Lloyd's Register of Shipping.

Ship's Name "CARROWDORE" Official No. 132047

Memorandum of alterations reported since ship was surveyed for assignment of Load Lines in _____

Small escape hatch to No. 1 Hold

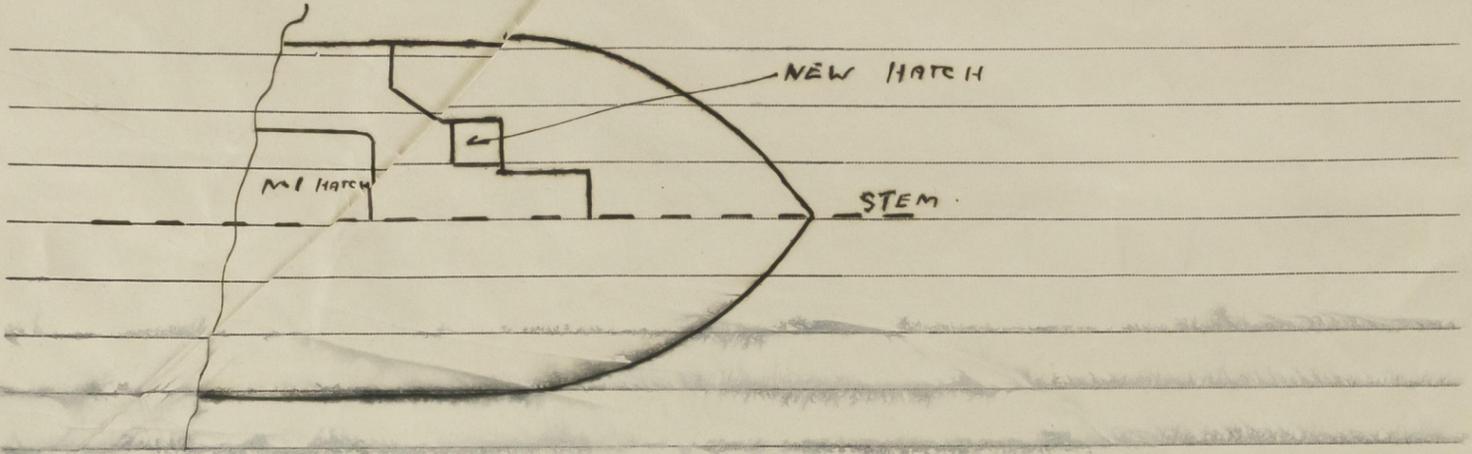
2'6 1/2" x 2'0" Height 3'0 3/8" coaming plate 5/16"

electric welded to deck, with a ladder down to the hold.

Efficiently covered by steel hinged watertight steel plate

secured in place by toggles

1.1/16" x 1.1/16" x 5/16" angles round top of hatch.
